# Technical Bulletin

<b>DP02</b>	<b>TB0040-2011</b>	<b>Elan Technologies</b>	
<b>From:</b>	<b>Billy Waits</b>		
<b>Subject:</b>	<b>Brake Pedal Upgrade</b>	<b>Date:</b>	<b>Sep 26<sup>th</sup>, 2011</b>

## Attention all Elan DP02 teams

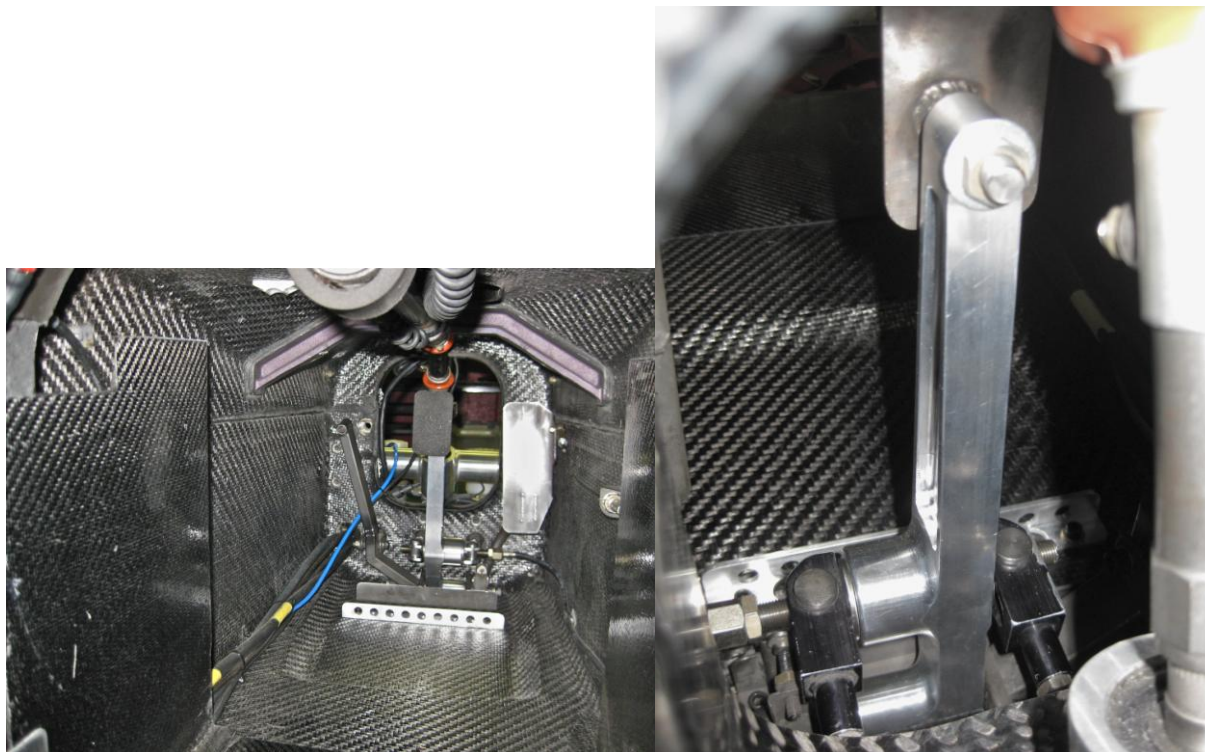
In response to team feedback, we have released a brake pedal upgrade for the DP02 chassis. This new pedal answers concerns pertaining to the repeatability of the bias control in response to pedal pressure by utilizing higher tolerance components.

1. The pedal is a direct bolt on replacement. No modifications to existing parts will be required.
